December 15, 2005

RE: Petition No. 4052 – Detroit Medical Center (DMC) proposed Gateway Arch over a portion of Mack Ave. between Beaubien and the I-75 Service Drive.

The petition was referred to the City Engineering Division – DPW for investigation and report. This is our report.

Drawing For Municipal Review

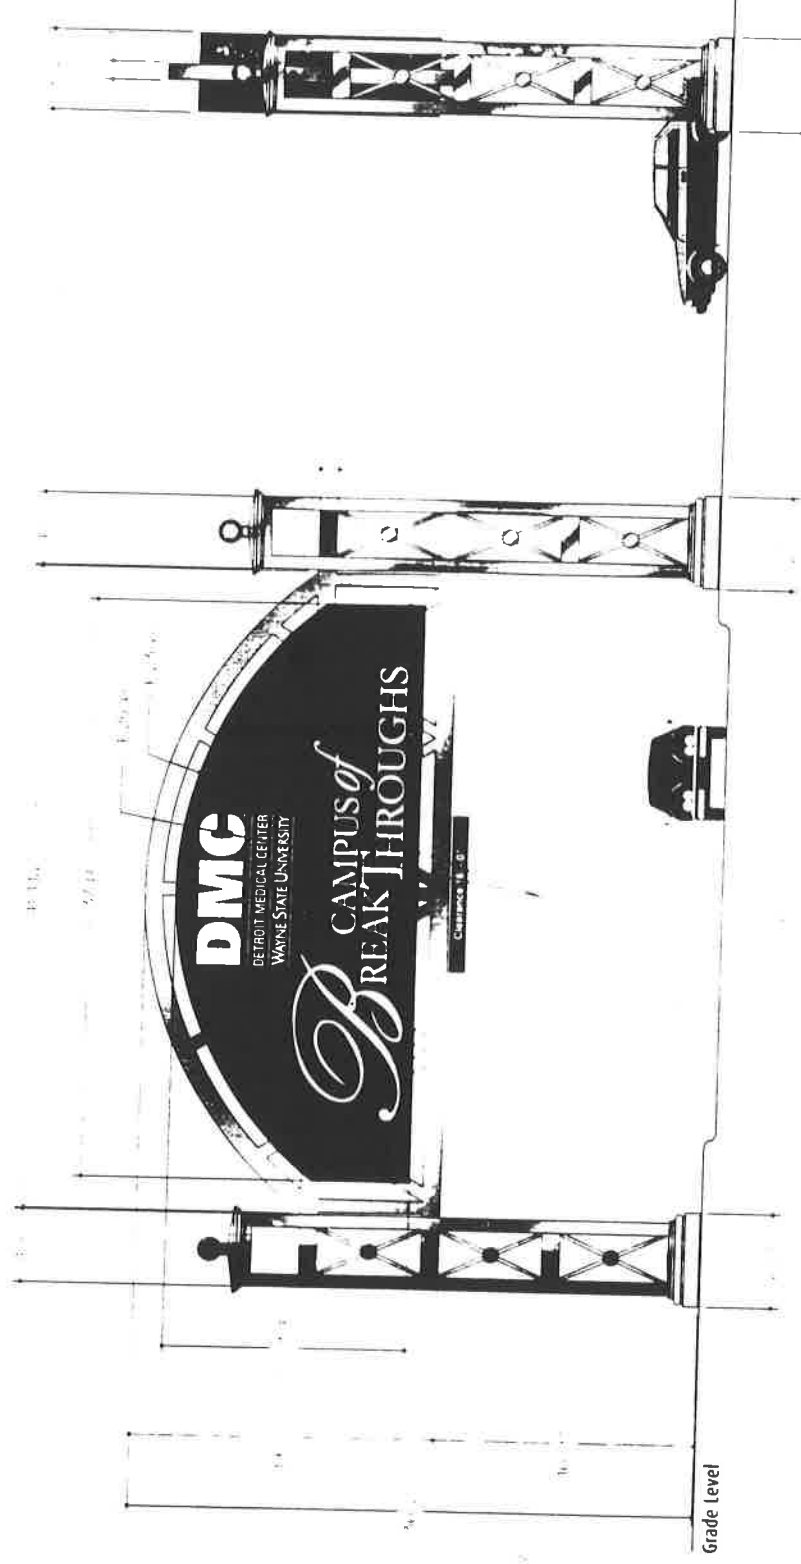
The proposed "Gateway Arch" encroachment will be installed approximately 142' from the center line of Beaubien Avenue, 120 feet wide, consisting of two (2) columns 4'-8" wide and 6'-0" at its base, with support piers 4'-0" in diameter, being 25'-0" in depth below the existing grade of both the median and the northerly berm (the area between the sidewalk and curb) of Mack Avenue. The proposed "Gateway Arch" encroachment will be 16'-9 1/2" high to the base and up to 36'-2" high to the top and will span across the westbound lane of Mack Avenue approximately 41'-1 1/2", as shown on drawings supplied by the "DMC" dated November 21, 2005.

The Traffic Engineering Division – DPW reports no objections with the requested encroachments upon the public right-of-way within a segment of Mack Avenue between the Chrysler Freeway (I-75) and Beaubien, for the installation of the sign and supporting structure for the "DMC", as shown in the proposed drawing dated November 21, 2005, as a pilot project.

The Public Lighting Department (PLD) reports having high voltage underground distribution, street lighting and traffic signal cables in 9'-3" concrete encased conduit banks and manholes in the area proposed to be encroached. Any structure proposed to be built shall maintain a 3 ½' horizontal clearance from PLD conduit banks and manholes. No structure can be built over PLD installations. Call MISS DIG to mark the location of PLD installations. Also, PLD recommends hand digging. The contractor for the "DMC" will be liable for any loss or damage to PLD. Also, access to any PLD installations shall not be restricted because of the encroachment.

The Detroit Water and Sewerage Department (DWSD) reports having an existing DWSD 13'-6" cylindrical sewer and 12" water main in close proximity to the proposed underground and overhead encroachments in Mack Avenue, east of Beaubien. In addition there may also be catch basin lines located in said Mack Avenue in the area of the proposed encroachments.

DWSD has no objection to the proposed encroachment for sign installation provided minimum clearances are maintained and the petitioner agrees to relocate the water main and any catch basin lines that may interfere with the construction or are in close proximity to the construction as deemed necessary by DWSD.

PROVIDED, That the encroachment does not exceed the proposed 142' from the center line of Beaubien Avenue, 120 feet wide, consisting of the two (2) columns 4'-8" wide and 6'-0" at its base, with support piers 4'-0" in diameter, being 25'-0" in depth below the existing grade of both the median and the northerly berm (the area between the sidewalk and curb) of Mack Avenue, and be 16'-9 1/2 " high to the base and up to 36'-2" high to the top that will span across the westbound lane of Mack Avenue approximately 41'-1 1/2 ", as shown on drawings supplied by the "DMC" dated November 21, 2005; and further

PROVIDED, That any structure proposed to be built shall maintain a 3 1/2' horizontal clearance from Public Lighting Department (PLD) conduit banks and manholes. No structure can be built over PLD installations. Call MISS DIG to mark the location of PLD installations. Also, PLD recommends hand digging. The contractor for the "DMC" will be liable for any loss or damage to PLD. Also, access to any PLD installations shall not be restricted because of the encroachment; and further
